SUBJECT: Forwards response to Quality Assurance Branch 810714  
 request for addl info re facility SER.

Subject: Palo Verde Nuclear Generating Station  
(PVNGS) Units 1, 2 and 3  
Docket Nos. STN-50-528/529/530  
File: 81-056-026; G.1.10

RESPONSE TO  
REQUEST FOR ADDITIONAL INFORMATION  
PALO VERDE NUCLEAR GENERATING STATION

Figure 17.2-1

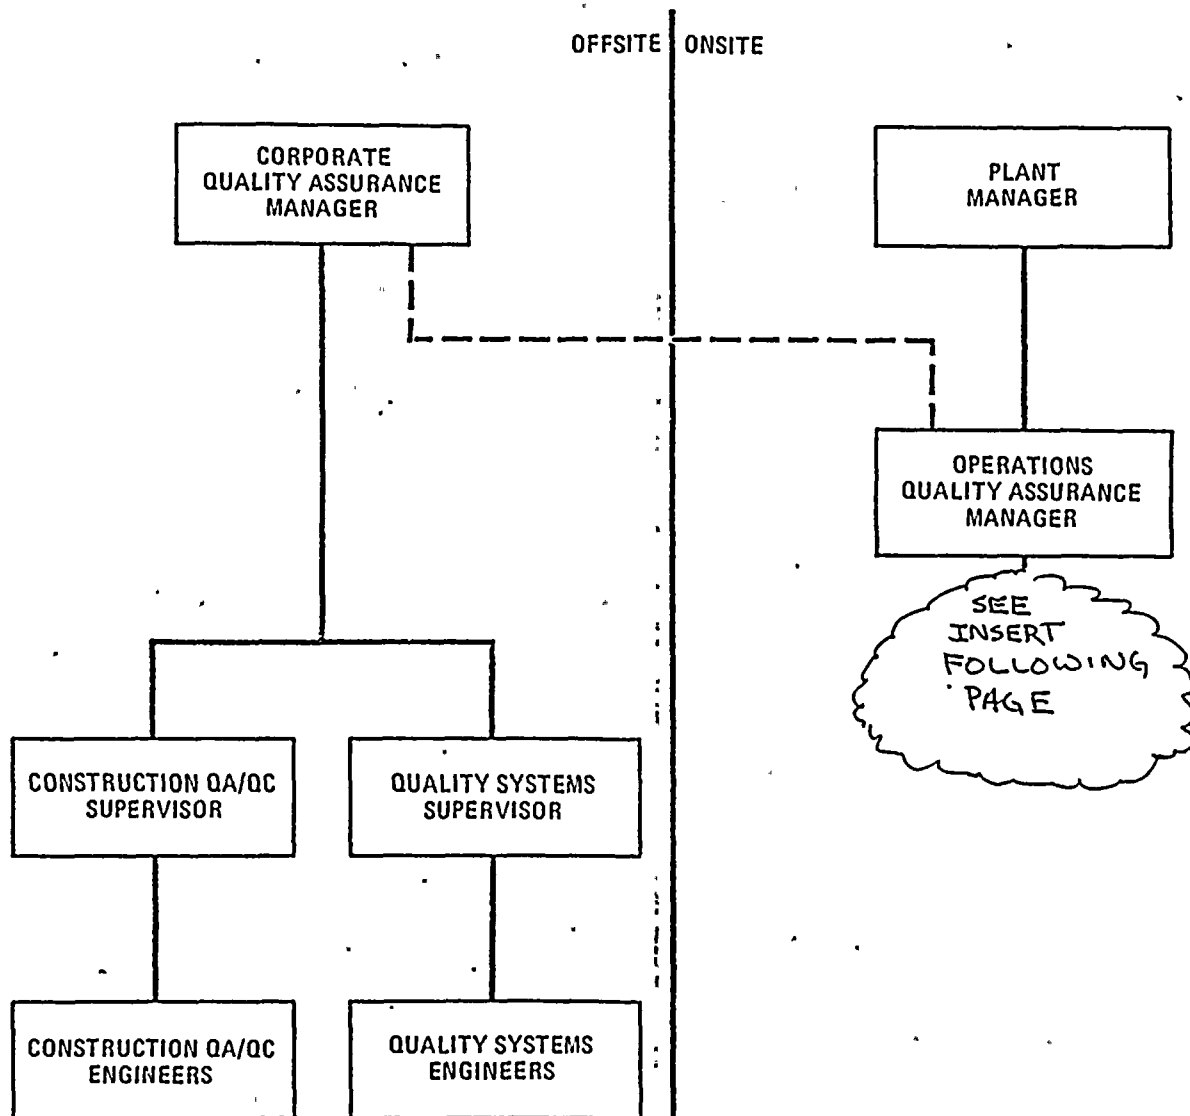
Section 17.2.1.3.2 indicates the Operations QA Manager "receives functional and technical guidance direction from the Corporate QA Manager", and Figure 17.2-1 has a dashed line between these two positions which the legend indicates as "functional and technical guidance." (Emphasis added) It is the staff position that the organization shown is acceptable if "guidance" is eliminated from the first quotation and changed to "direction" in the second. Commit to meet this position or provide an alternative for our evaluation.

RESPONSE: The response is included in amended sections 17.2.1.1.6 and 17.2.1.3.2 and Figure 17.2-1. These responses more correctly define Arizona Public Service Company's Quality Assurance responsibilities. *attached*

— LINE AUTHORITY — DIRECTION  
 - - - FUNCTIONAL AND TECHNICAL GUIDANCE
